**CITY OF KIRKLAND
NOTICE OF DECISION**

Permit application: [DRV19-00461](#)

DESIGN REVIEW BOARD DECISION

DATE: June 16, 2020
FILE NUMBER: DRV19-00461
PROJECT NAME: 112 LAKE STREET SOUTH MIXED USE PROJECT
APPLICANT: Thomas Hembra with Encore Architects
PROJECT PLANNER: Scott Guter, AICP, Senior Planner

1. COMMERCIAL STREET FRONTAGE | RETAIL B AND RETAIL C PALETTE DIFFERENTIATION

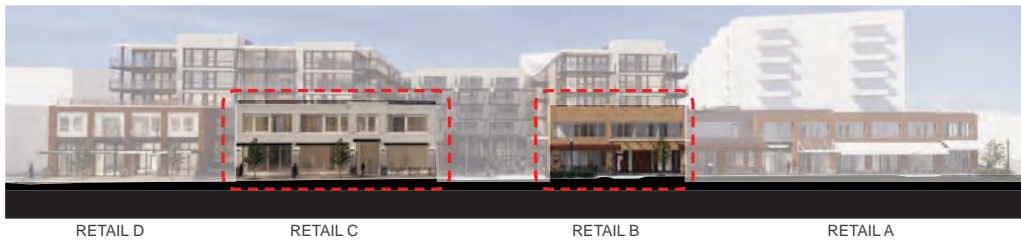
- Storefronts: The color range between Retail B and C was similar in color and there should be a broader color distinction between the two storefronts. The DRB asked the applicant to continue to develop the storefront color design.

- In response, the applicant revised the colors on the plan’s material palette pages (see pages 88-92 of Attachment 2). Both east and north building materials were updated with a lighter color palette (see pages 41-49 of Attachment 2). Page 10 clearly differentiates the proposed color of Retail C from Retail B. The applicant also provided more granular details to material treatment of Retail C discussed in Section III.B.1. The upper stories color palette was revised on page 39 replacing the Extra White color with a softer shade of white called Greek Villa. The DRB were in support of the applicant’s material and color revisions.

1. COMMERCIAL STREET FRONTAGE | RETAIL C DEPTH

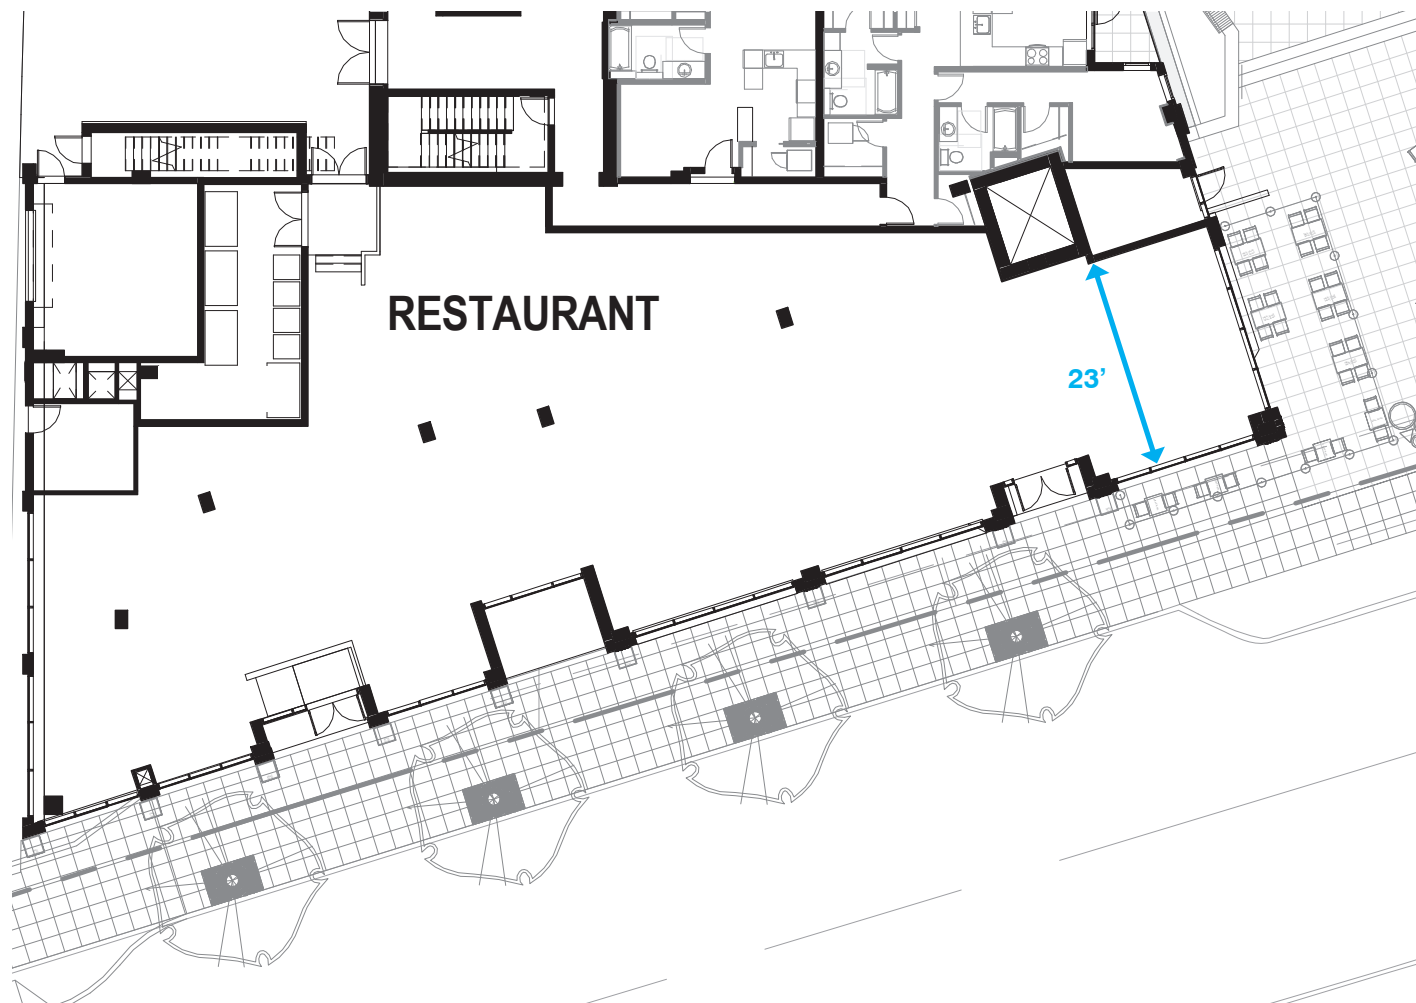
1. Retail C Depth

Retail depth has been increased to exceed the minimum 20' depth requirement by revising the circulation routing previously restricting the retail depth.
